Access Compliance Report

Public Rights-of-Way

(Curb Ramps)

Intersection ID: 6747	Main Street: JUNIPERUS_DR	Cross Street: BELMAR_PLACE_RD	Location: NW
ADA ID: E471E70203E1	Ramp Type: PerpDiag	Initial Pass/Fail: Fail	Overall Compliance: No
			Severity Score: 13.75

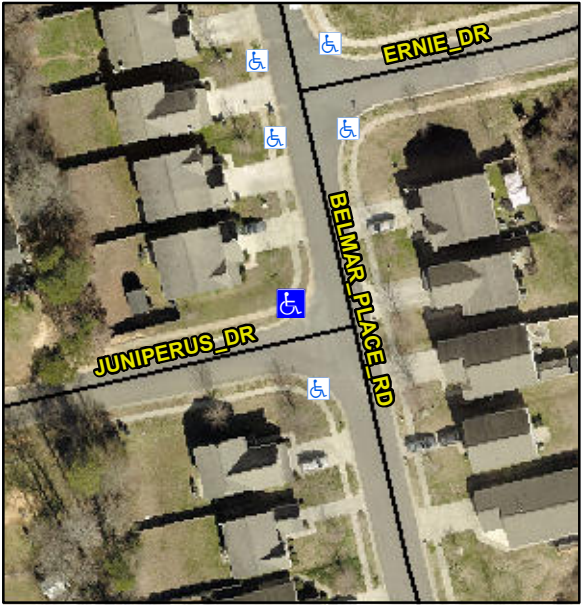
Codes/Mitigation Info/Possible Solution			Field Measurements/Component Compliance		
	Possible Solutions:		Compliance	Description	Data
	Remove & Replace Curb Ramp With Two New Directional Ramps or Equivalent.		N/A	Ramp Length (in)	48.0
			Yes	Ramp Width (in)	48.0
			N/A	Flare Type LT	N/A
			N/A	Flare Slope LT (%)	N/A
			N/A	Flare Traversable LT?	N/A
			N/A	Landing Length (in)	N/A
			N/A	Landing Width (in)	N/A
			N/A	Landing Slope (%)	N/A
			N/A	Landing X Slope (%)	N/A
<p>Surveyor Notes:</p> <p>N/A</p> <p>PROW/ADA:</p> <p>R304.2.2, R304.5.3</p>			N/A	Flare Type RT	N/A
			N/A	Flare Slope RT (%)	N/A
			N/A	Flare Traversable RT?	N/A
			N/A	DWS Provided?	N/A
			N/A	DWS Contrast?	N/A
			N/A	DWS Length (in)	N/A
			N/A	DWS Full Width?	N/A
			N/A	DWS Offset (in)	N/A
			N/A	Gutter Ponding?	N/A
			N/A	Gutter Lip Ht (in)	N/A
<p>Total Cost:</p> <p>\$ 3200.00</p>			No	Painted X Walk1?	No
				X Walk 1 Direction	To S
			N/A	X Walk 1 Width (in)	N/A

X Walk 1 Slope (%)	2.3
				X Walk 1 X Slope (%)	5.6
			N/A	Ramp inside XWalk1?	N/A
				Road Slope (%)	2.9
				Road X Slope (%)	0.8
			N/A	Any Obstructions?	N/A
				Obstruction Type	
			N/A	Storm Grate/Utility Hazard?	N/A
				Storm Grate/Utility Type	
			N/A		N/A
			Yes	Surface Condition? (G/P)	Good
